# Field Service Bulletin Trucks

Date Group No. Release Page 10.13 **284 047 02** 1(10)

Oil Level Sensor Harness Wire Splice VAH, VHD, VN, VT

### FSB 284-047, Oil Level Sensor Harness Wire Splice

W2085817

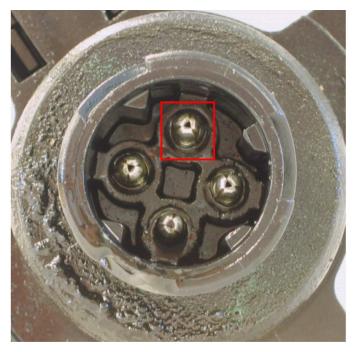
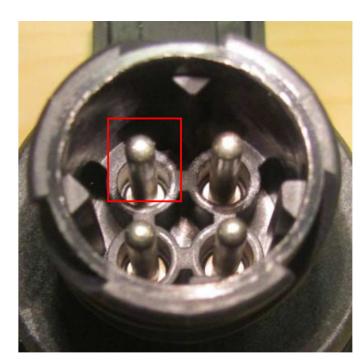
Some VOLVO vehicles built between January 2004 and September 19, 2013 may experience an oil level sensor failure that leads to oil contamination into the engine wire harness. A new anti-wicking pigtail splice kit, part number 85137983, is now available. Follow the procedure below if wicking is observed. Chassis with build date September 20, 2013 and later have the new solid pin connector and no action is required. The oil level sensor part number 21521353 with hollow pin type connector is now replaced with the new solid pin type connector oil level sensor part number 22022794. The new solid pin connector does not allow oil to wick into the engine harness.

If a sensor is being replaced for electrical faults and oil has not wicked into the harness, **REPLACE THE SENSOR ONLY**.

If a sensor has failed **AND** is wicking oil into the engine harness, **REPLACE THE SENSOR AND INSTALL THE PIGTAIL AS INSTRUCTED IN THIS BULLETIN**.

If the engine harness is being replaced for other reasons and the sensor connector is the older hollow pin type, **REPLACE THE SENSOR ONLY**. The new harness will **NOT** require the pigtail kit.
